**[Docket No. FAA-2004-19960; Directorate Identifier 2004-CE-47-AD; Amendment 39-14153; AD 2005-13-16]**

#### **Airworthiness Directives; The New Piper Aircraft, Inc. PA-34 Series Airplanes**

**ACTION:** Final rule.

Figure 1.

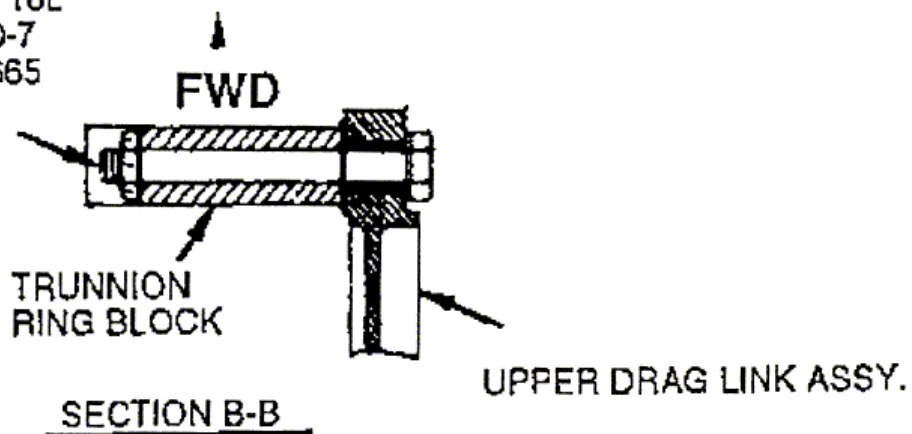
Actions	Compliance	Procedures
(1) Replace the bolt and stack up that connects the upper drag link to the nose gear trunnion with new parts (or FAA-approved equivalent part numbers (P/N)) of the following: (i) Piper P/N 400 274 (AN7–35) bolt; (ii) Piper P/N 407 591 (AN960–716L) washer, as applicable; (iii) Piper P/N 407 568 (AN960–716); (iv) Piper P/N 404 396 (AN320–7) nut; and (v) Piper P/N 424 085 cotter pin.	Within the next 100 hours time-in-service (TIS) after January 28, 1994 (the effective date of AD 93–24–14), unless already done within the last 400 hours TIS before January 28, 1994 (compliance with AD 93–24–14). Repetitively replace thereafter at intervals not to exceed 500 hours TIS. Continue to repetitively replace until the actions in paragraphs (e)(2) and (e)(3) of this AD begin.	Follow Figure 1 of this AD.
